MEETING MINUTES

SUBJECT: RBRP JV-273: S.R. 2002, Section 000 over Reynolds Run Bridge Replacement Project , Little Britain Township, Lancaster County
Consulting Party Meeting

EXHIBIT LAYOUT
2 - 10' LANES, 2 - 2' SHOULDERS

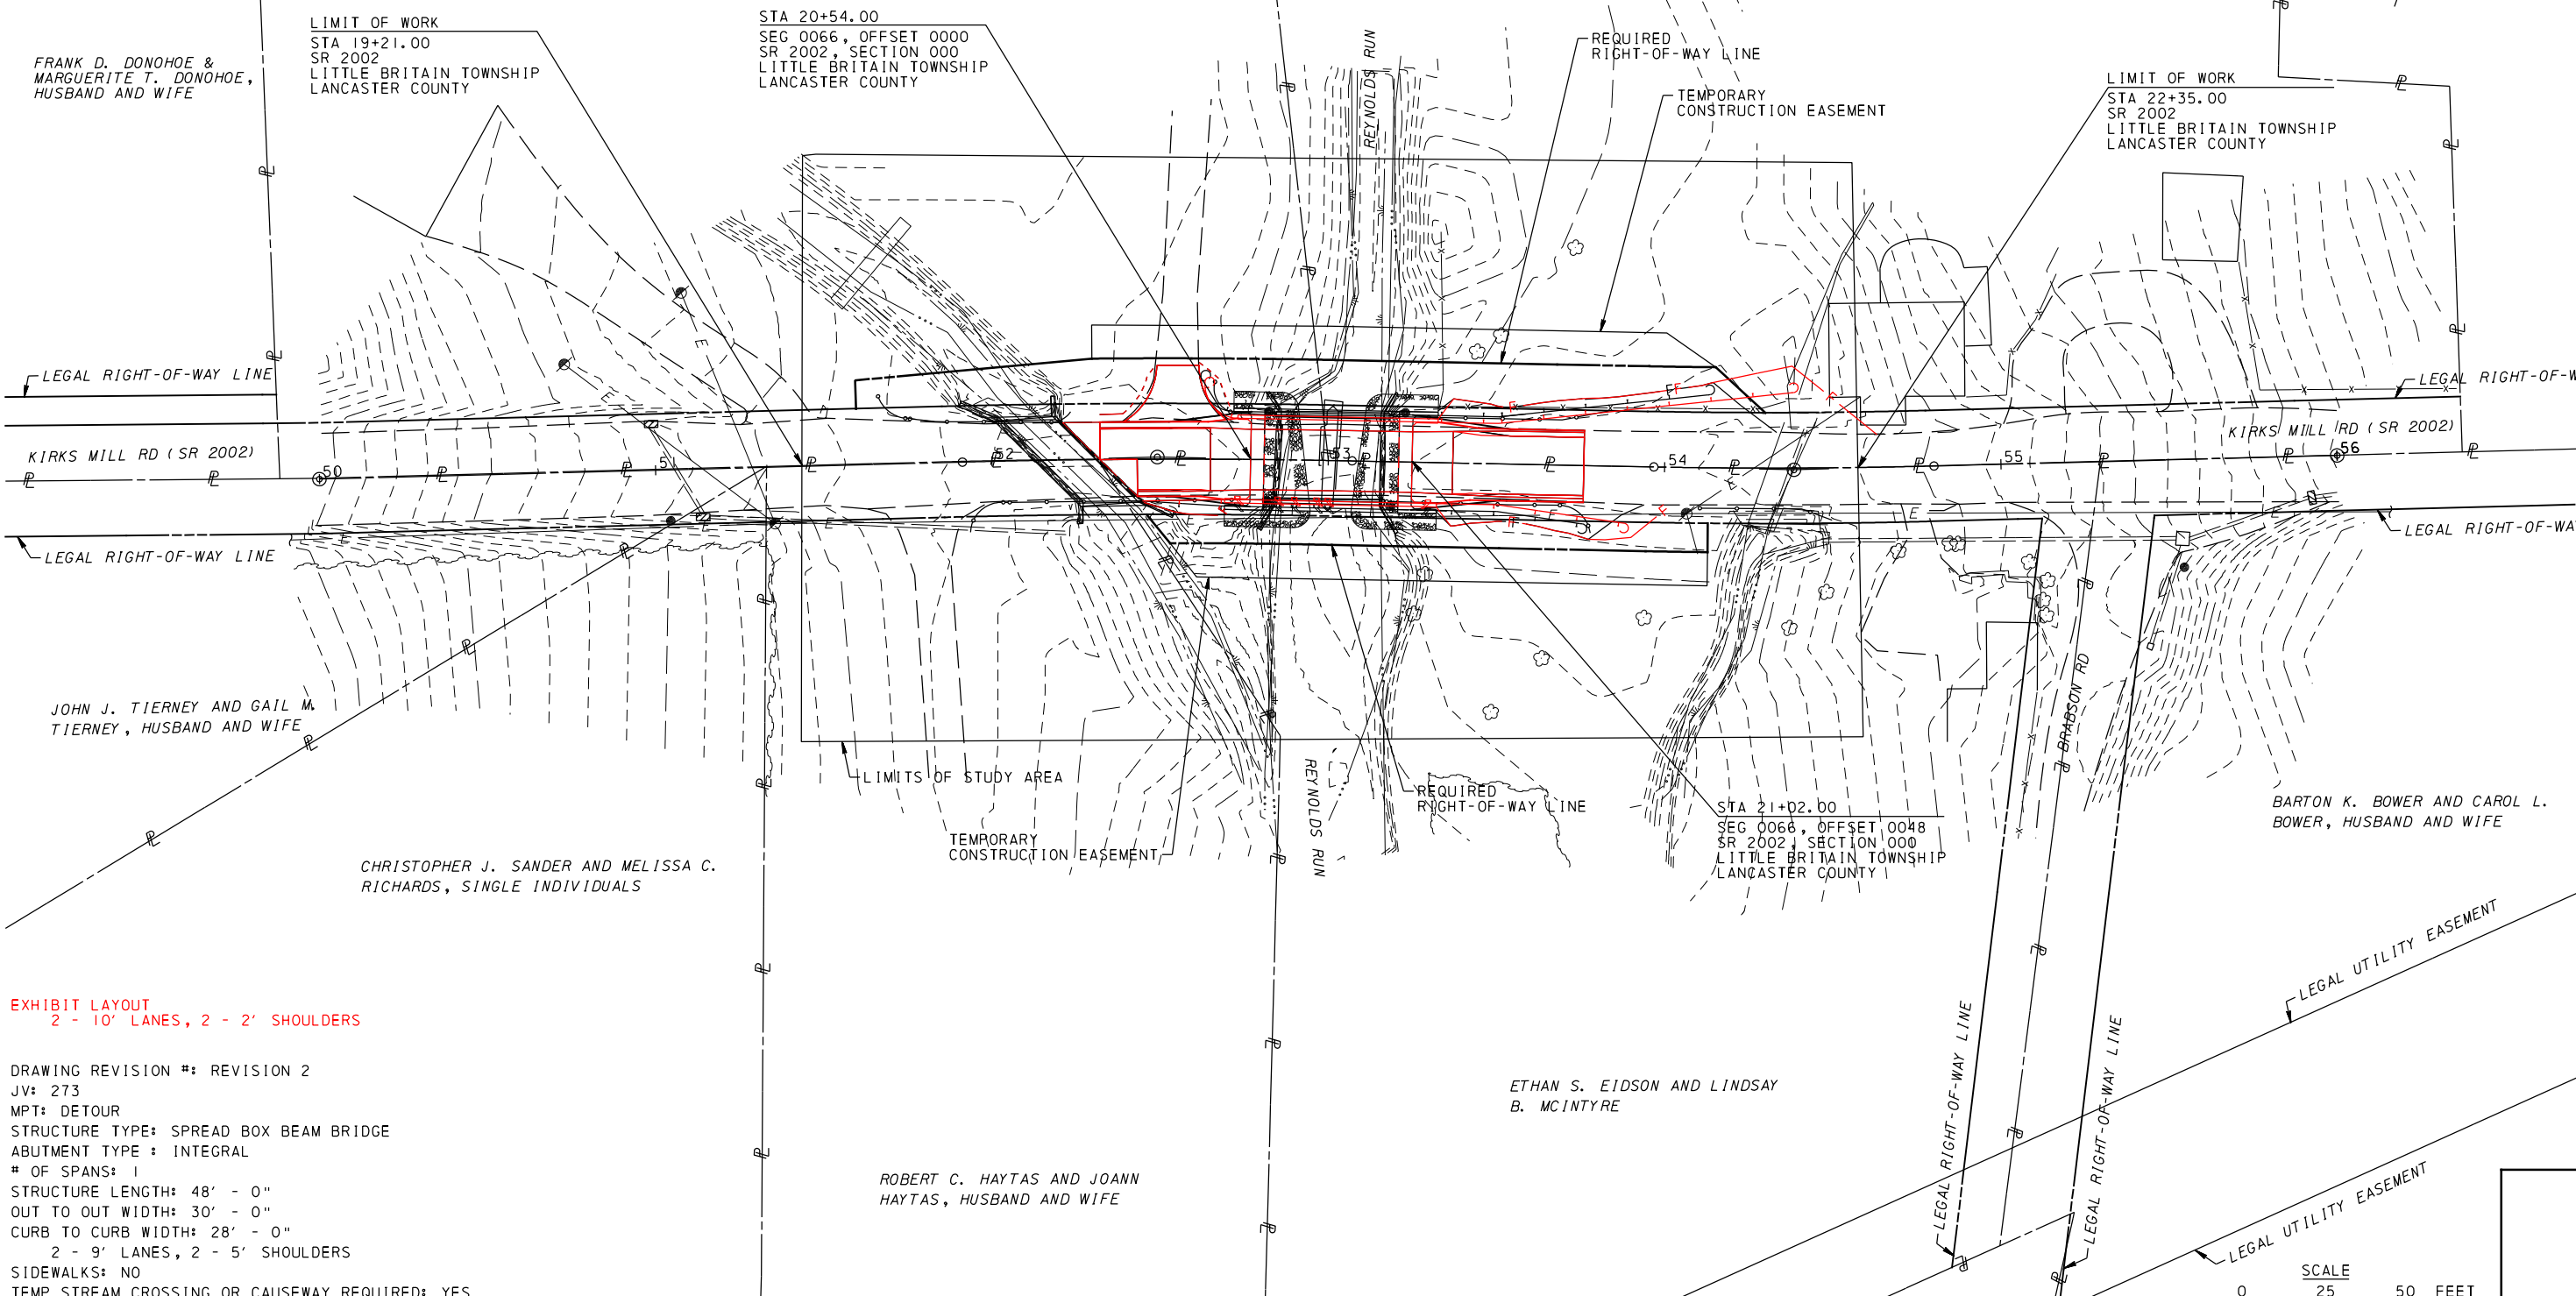
Plan Review: The plan reviewed at the meeting is attached. Following questions regarding the width of the bridge and the possibility of narrowing it, Ken Wright discussed a conceptual design option that decreased the curb-to-curb width of the bridge to approximately 24 feet. This option was developed in response to a question received during the March 22, 2016 public meeting asking whether additional right-of-way would be required if the bridge width was maintained at the current width. The design would require additional guiderail and right-of-way in the northeast quadrant within the O'Malley's Kirks Mill property. This option was deemed a poor alternative by the O'Malleys because of the proximity of the guiderail to the mill building and the need for additional right-of-way and additional fill on their property extending over the mill race.

The perception is that the guiderail, the increased width of the bridge and the roadway taper will direct the traffic into the mill. The O'Malleys commented that there was an accident and a police report from about two years ago. Ken Wright explained that the traffic will travel with the alignment, the centerline double yellow stripes, rather than the tapers of the outside edge of the asphalt. The new asphalt will be striped with line painting which will guide traffic and show that, although the shoulders are getting wider at the structure, the perceived travel corridor width remains the same. The guide rail is designed for each site based on the Length of Need (LON) and is based on characteristics of the roadway and the location of obstructions. The LON is designed to provide protection and shield the traveling public from these obstructions. The required LON for this site would extend beyond the dwelling on the mill property, if not flared as proposed on the plan, which would not be desirable. Also there is not enough room between the dwelling and the roadway for placement of guiderail due to the deflection distance required behind the guide rail.

Tail Race: The O'Malleys commented that the new plan shows a fill line into the tail race of the mill. As this is a conceptual plan, if the option was advanced, the final plan would show adjustments for the tail race to remain open.

Contributing Property: A question was asked regarding the absence of a contributing property on the plan in the northwest quadrant. Following the meeting, the plan preparer was contacted and stated that the building in that quadrant is not included on the plan because it is outside the study limits and outside the survey area. The property was reported in the Criteria of Effects Memo as a contributing resource and effects to the property were discussed. The building will not be physically affected by the project, but approximately 800 square feet of property will be acquired for placement of the new abutments, scour protection and guide rail.
